Addendum #1

**Port of Port Arthur
Truck Queuing Area and Laydown Yard
Rider 37 Project 1 – CSJ 0920-38-288**

Addendum Date: August 21, 2025

SHEET TITLE
DEMOLITION PLAN
PROJECT
RIDER 37 - PORT OF PORT ARTHUR TRUCK QUEUING AREA AND LAYDOWN YARD
221 HOUSTON AVENUE PORT ARTHUR, TEXAS 77641

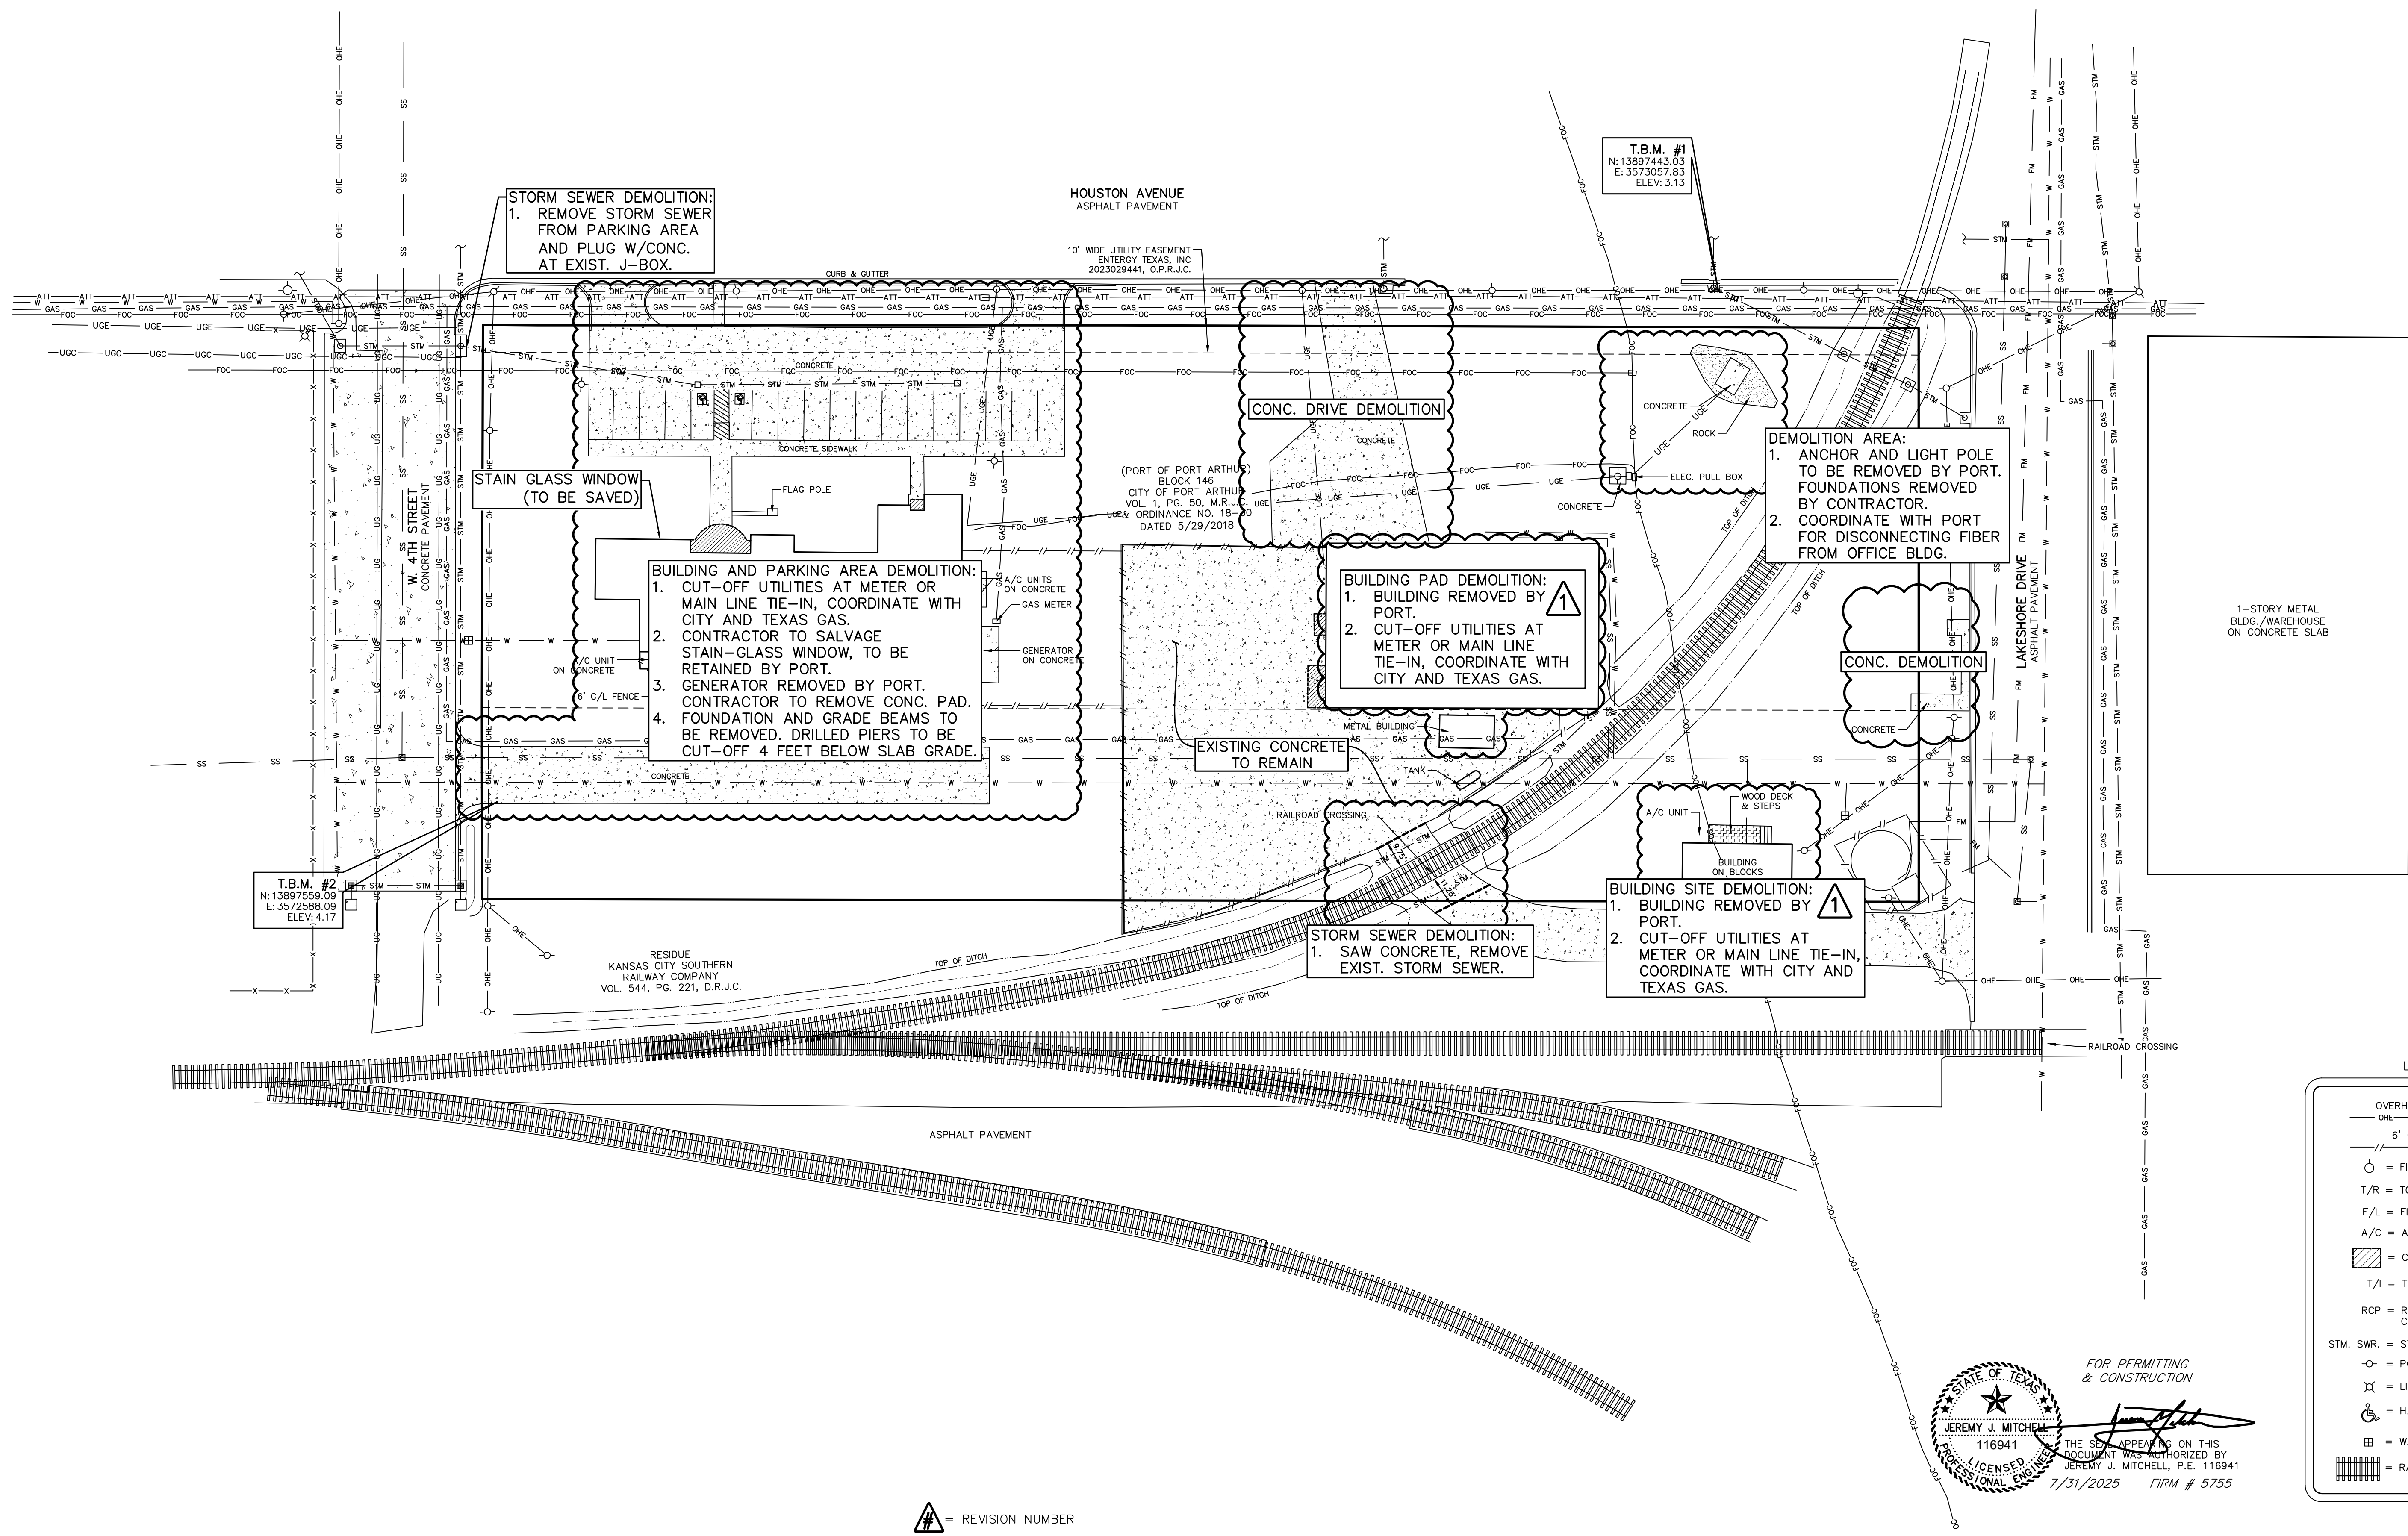
1. Demolition Plan updated to note buildings removed by port (sheet 4).
2. Turn Lane clarified as concrete paving with no asphalt (sheet 5).
3. Clarify trench details for CCTV (sheet 10).
4. Fencing details modified, top rail and bracing clarified, no bottom rail. Tension

SHEET TITLE	
DRAINAGE PLAN	
PROJECT	
RIDER 37 - PORT OF PORT ARTHUR TRUCK QUEUING AREA AND LAYDOWN YARD	
221 HOUSTON AVENUE PORT ARTHUR, TEXAS 77641

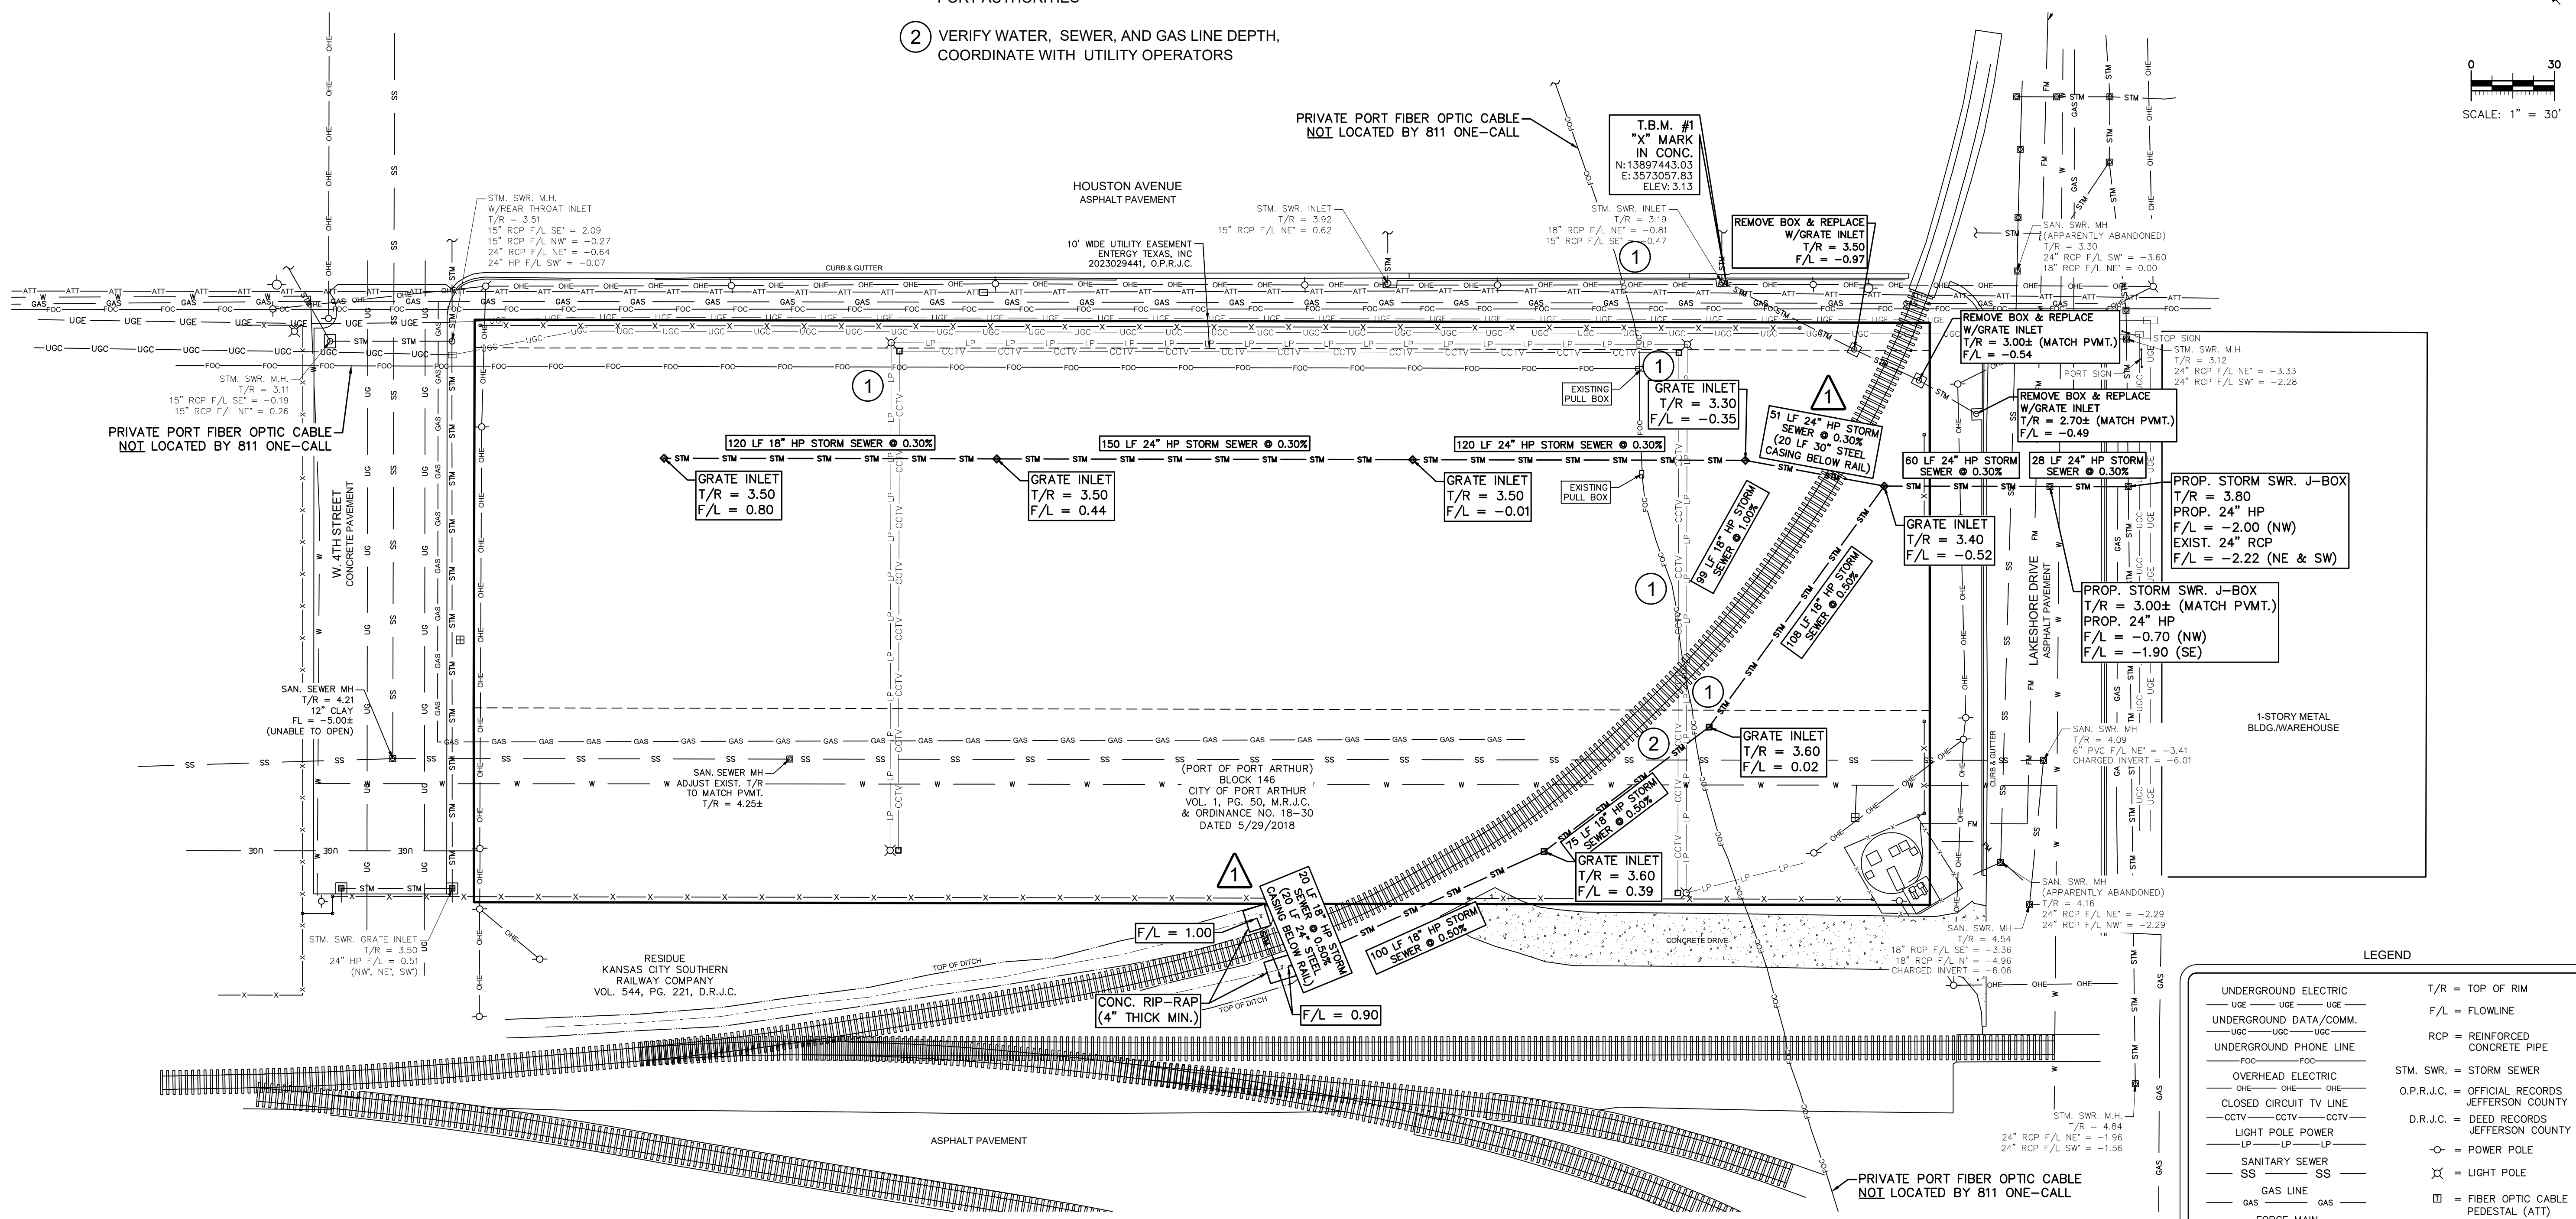
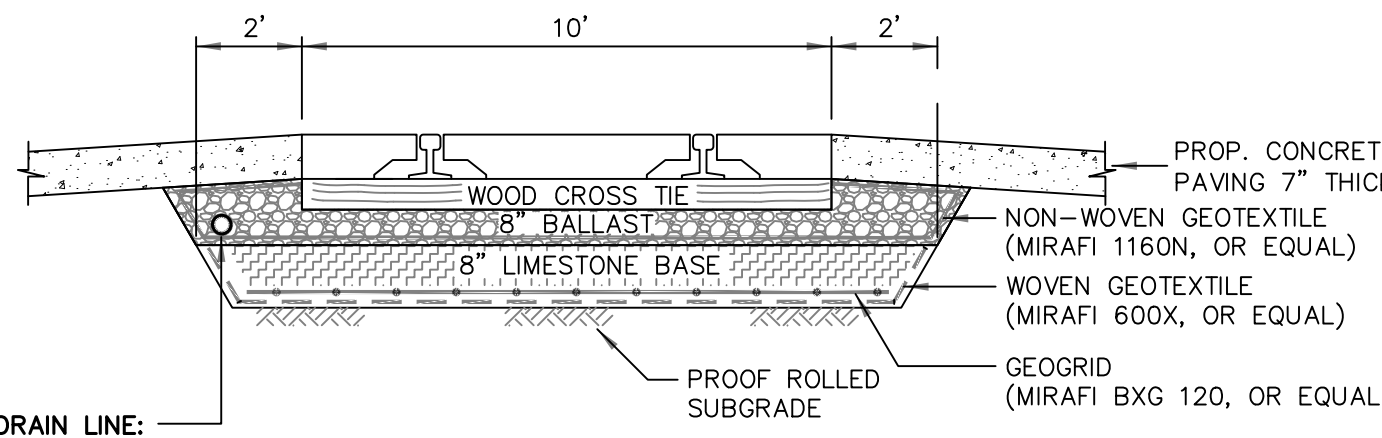
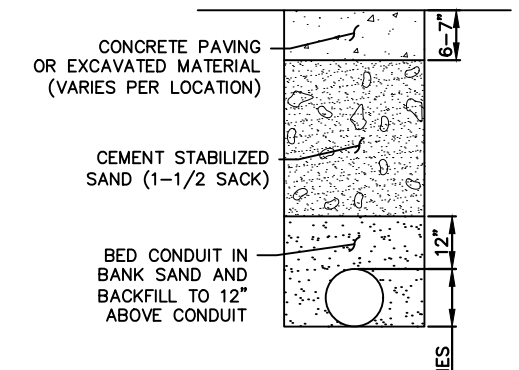
1. Bid items added (Demolition, Railroad Items, Traffic Control, etc.)
2. Steel casing around storm lines below rails, A36 standard wall thickness, smallest size necessary, no spacers. (30" steel on 24" hp, 24" steel on 18" hp) (sheet 8).
3. Rail work added to scope, remove and replace rails and ties (sheet 9).
4. Curb detail (sheet 13).

NO.	REVISION NOTES	DATE
1	ADDED STEEL CASING BELOW RAIL	8/20/2025
